**From:** Jerry Hintze  
**To:** Dennis Killian; George Cross  
**Date:** 3/22/2007 2:53 PM  
**Subject:** Bob Allen - Siemens

# History of IPSC Experience with ABT Burners

Presentation for Siemens, March 15, 2007

Reference: Contract 04-45606 -Unit 2 Low NOx Burners

Burner Barrel Erosion, F5 Burner

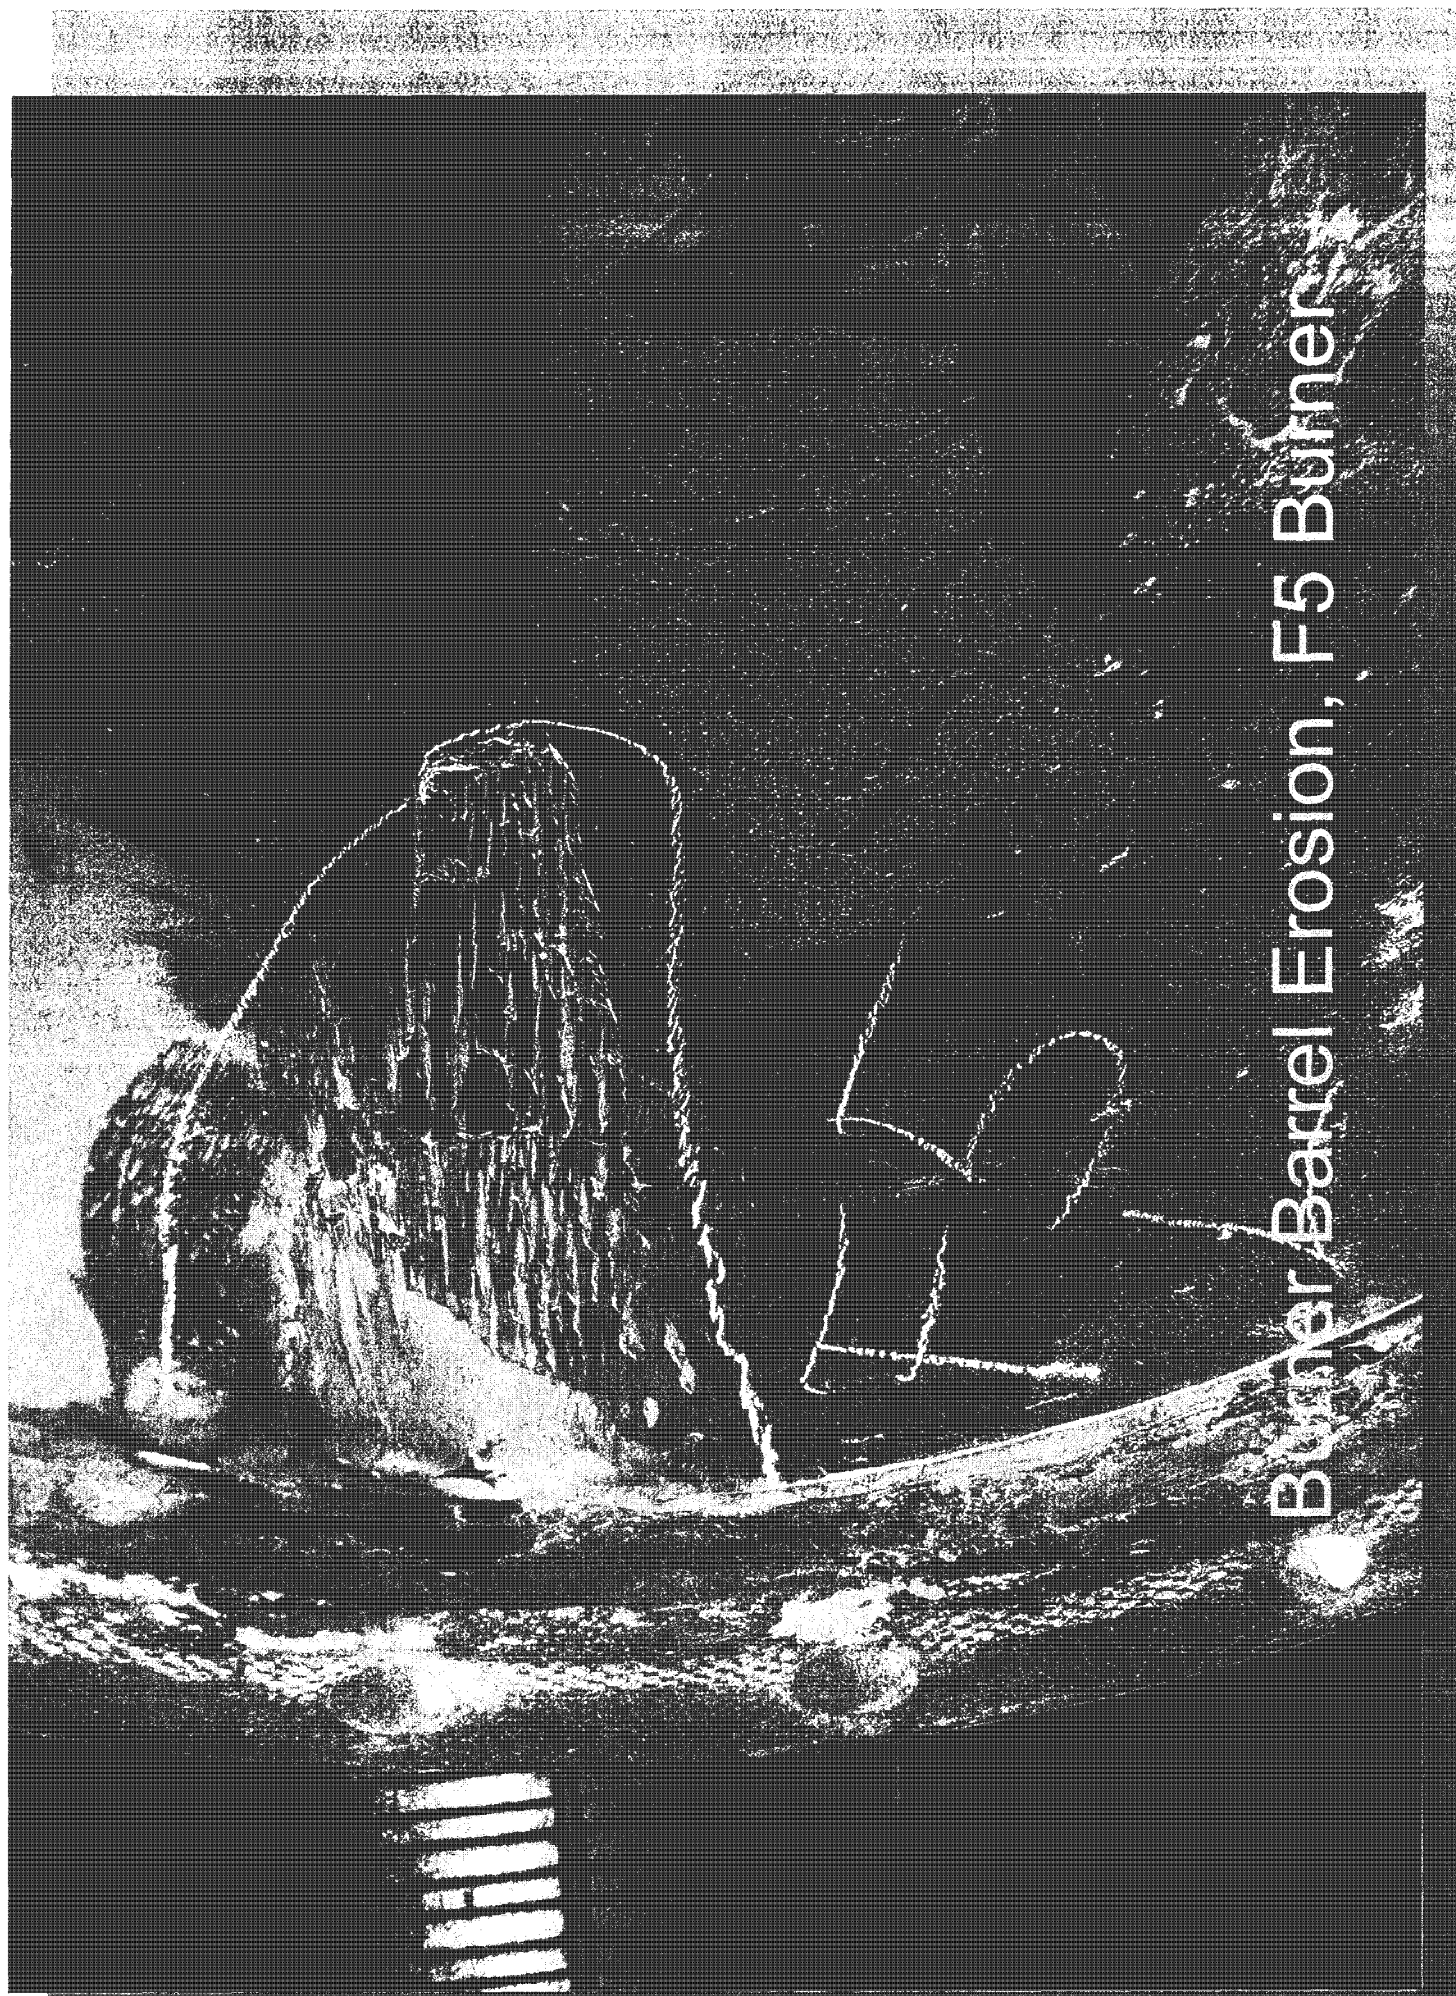
- All 48 fuel injectors were pulled and inspected
- 20 of the tips were irreparable and replaced with straight tips. 28 had tip liners installed
- 7 burners with holes in the injector barrel on the horizontal plane. Many more very thin. All had erosion in this area.
- Diffuser and wear liner installed on all 48 burners
